**CITY OF BOULDER**  
**PLANNING BOARD MEETING AGENDA**  
**DATE:** October 30, 2014  
**TIME:** 6 p.m.  
**PLACE:** Council Chambers, 1777 Broadway

**CITY OF BOULDER**  
**PLANNING BOARD AGENDA ITEM**  
**MEETING DATE: Oct. 30, 2014**

**AGENDA TITLE:** CONCEPT PLAN REVIEW AND COMMENT: Request for public and Planning Board comment on a proposal for a redevelopment that includes a mix of uses including office, retail, restaurant, and multi-family residential apartments. Proposed are approximately 103,000 square feet of office, 12,000 square feet of retail/office "flex" space, 12,000 sf of retail/restaurant, and 242 residential units comprised of studio, one, two and three bedroom units along with live/work units. The development proposed would require a rezoning for the two areas of the property. This is the second Concept Plan review submitted for this project.

**Project Name:** Reve Pearl District  
**Location:** 3000 Pearl Street; 2170, 2100 30<sup>th</sup> Street and 2120 32<sup>nd</sup> Place  
**Size of Tract:** 6.01 Acres (186,676 square feet)  
**Zoning:** Business Regional-1 (BR-1) and Industrial General (IG)  
**Comprehensive Plan:** General Business (GB) on the south a

**Figure 15: Current Concept Above Compared to Original Concept Below**

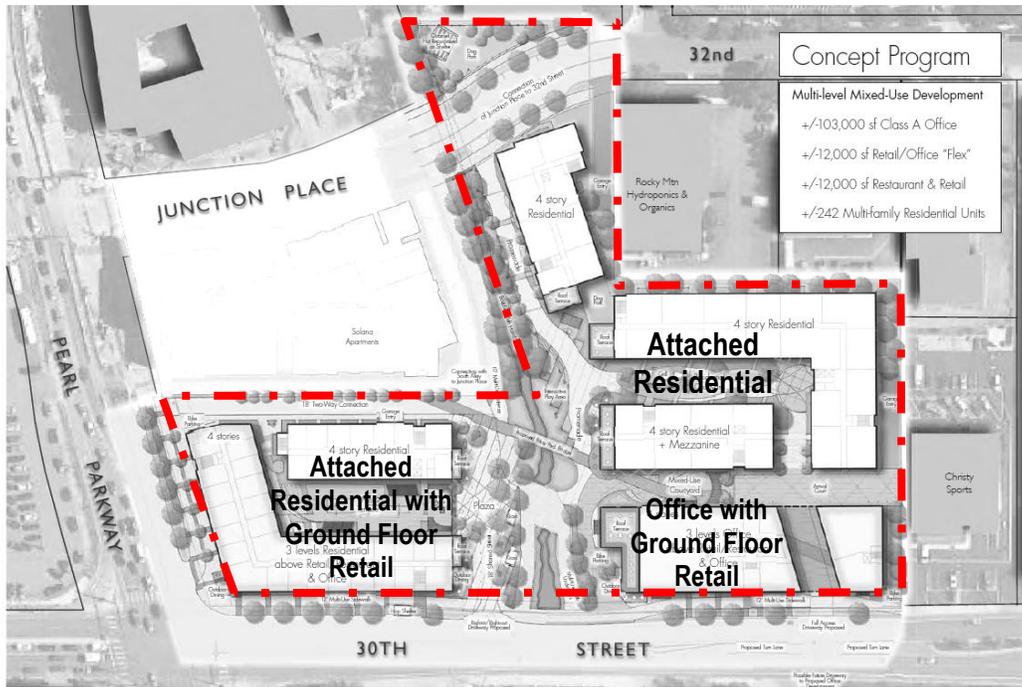
**Key Issue 1: Does the Concept Plan address Planning Board Comments from the Previous Concept Plan Review?**

At the June, 5, 2014 Planning Board hearing, the board discussed several key issues regarding the original Concept Plan. The meeting minutes in their entirety are available at the following weblink: [June 5, 2014 PB Hearing Minutes](#). At the hearing, the Planning Board presented several suggestions to the applicant with regard the building and site design and recommended the applicant submit a second Concept Plan to address them. Among the key suggestions was to include residential over retail on the northwest corner to improve compatibility with the TVAP Guidelines. Below in Figure 15 is a comparison of the current concept plan with primarily residential and retail at the northeast corner and office fronting 30th Street on the south side of the site with residential behind; compared to the original concept plan with office at the corner of 30th and Pearl streets and all residential land uses on the south side of the site.

**Figure 18: Excerpt from Concept Plan Book illustrating potential urban style playgrounds**

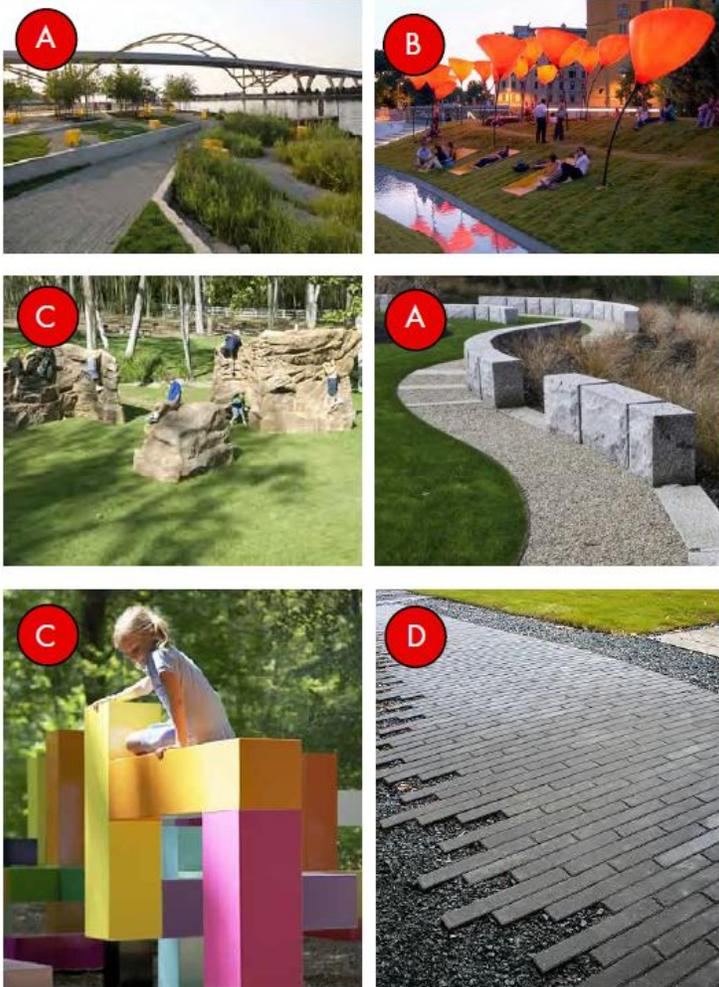
Similarly, with regard to the creative “urban playgrounds” that are illustrated in precedent images, shown in Figure 18 as project plans progress identifying areas that provide family oriented amenities such as playgrounds and daycare should be considered.

**Figure 21:**  
Illustrations of Activated Streetscape  
Planned along 30<sup>th</sup> Street

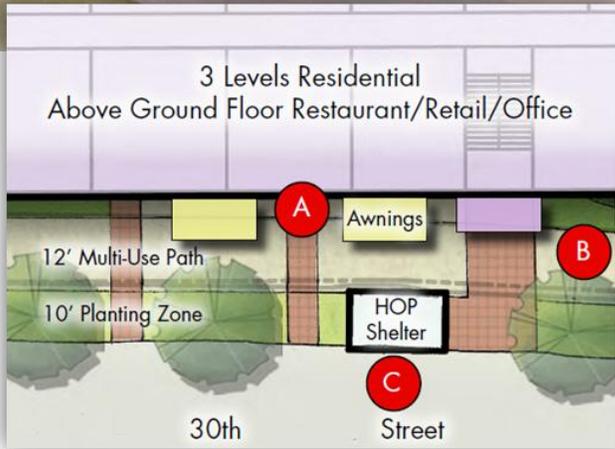
As also shown in Figure 21, a rendering that is presented on page 27 of the concept plan book illustrates the type of storefront and activity planned for the ground floor along 30<sup>th</sup> Street. One consideration that staff notes with regard to ground floor uses is that in the options of the ground floor presented, office is indicated as one of the options. The BVRG guideline 5.1.E, further discussed in Key Issue 4, recommends that interior spaces such as dining areas and merchandising displays "spill" onto walkways and plazas on the ground floor. Inherent in that guideline is the assumption that the ground floor will be activated by retail types of uses that create greater activity than offices such as banks or other low turn-over types of uses. As project plans progress, the applicant should look to ways to plan for active uses on the ground floor. Understanding that the more active uses could come in over time, the applicant should consider ensuring higher ceilings on

the ground floor along with storefront window systems to establish the retail vernacular that can adapt over time. Figure 22 illustrates an elevation along Pearl Street with non-residential on the northwest corner of the ground floor.

Figure 25a and b  
 Site Location with Natural Grade (above in 1958 USGS topo) compared to Altered Grade today (below)

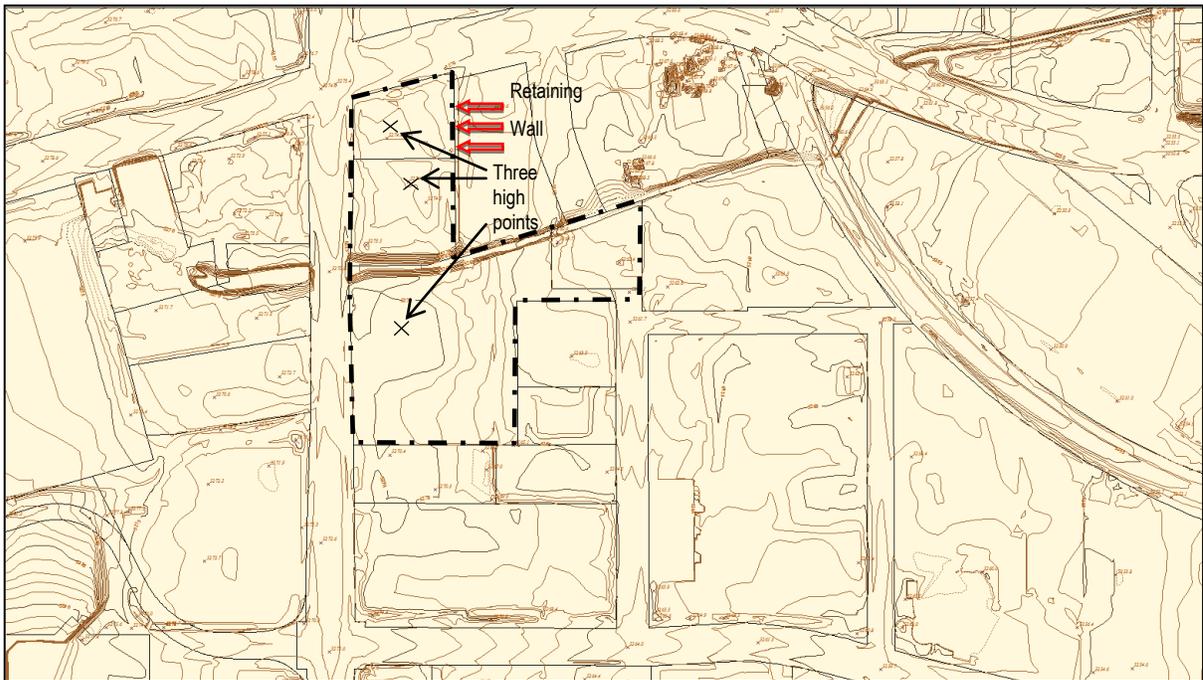
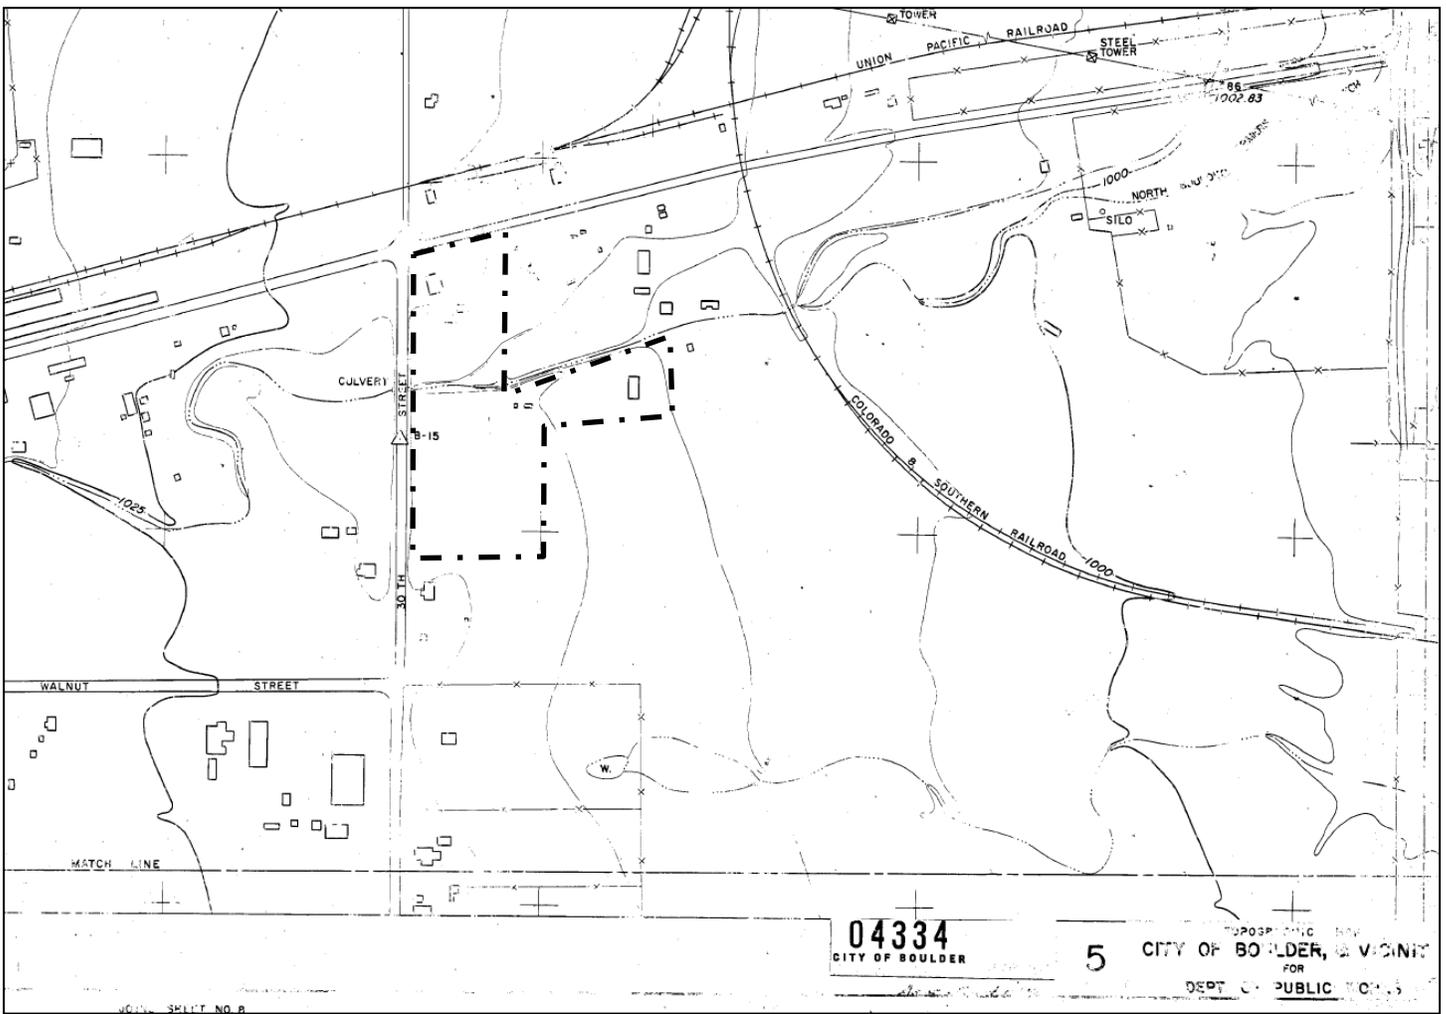
As noted in the previous Concept Plan, is the proposal to return the existing site’s altered topography back to the original grading, shown in Figure 25a from a 1958 USGS topographic map. As is understood, the site was altered a number of years ago with fill added to bank the site toward 30<sup>th</sup> Street and create an auto display area, as can be seen in the current topographic map in Figure 25b. The plan to remove the fill and retaining wall will help to bring to fruition, the proposed local access road at the east side of 3000 Pearl property as envisioned in TVAP. As shown in Figures 26a and 26b is the retaining wall on-site and where the wall is located in relation to the TVAP connections plan. The existing retaining wall usurps the opportunity to create the connection for both properties to use that connection without extraneous pavement. Prior to Site Review, the applicant and the adjoining property owner at Solana Apartments will be required to establish an agreement on how best to configure the access between the two properties, with city approval of that agreement.
